**Forestry Commission responses to Examination questions regarding Rampion 2 Offshore Wind Farm**

**COD 1.1 – Horizontal Directional Drilling (HDD)**

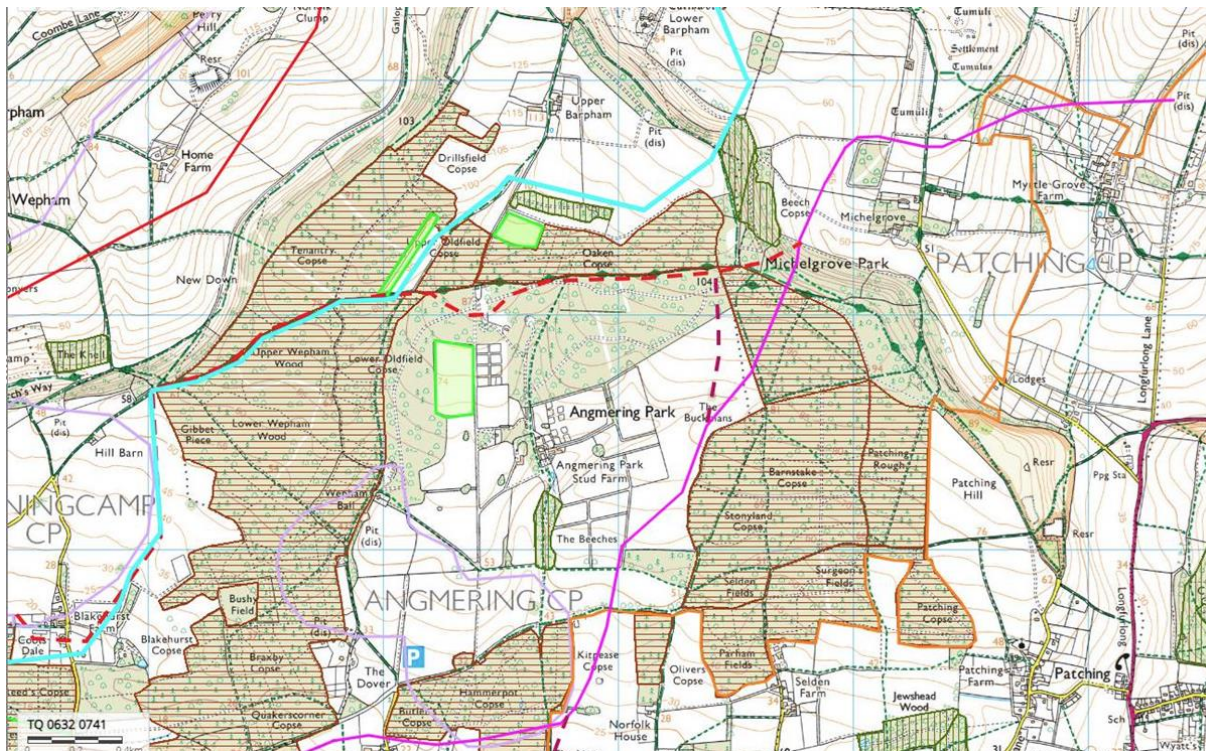
In addition, the route appears to have changed from what we had consulted on during the Consultation stage to a route that which now requires HDD over a greater extent of ancient woodland including Oaken Copse and Michelgrove Park in addition to Wapham Wood (ie from the turquoise route to the dashed red route in the below map). We are of the understanding from previous engagement with this project that it would not be viable to drill the distance involved to avoid damage to ancient woodland via this route, and that there would be a need for clearance of ancient woodland. We ask that further consideration and assurance are given regarding to the feasibility of this particular aspect of the route, and ask the applicant to demonstrate how previous concerns regarding this part of the route have been overcome.
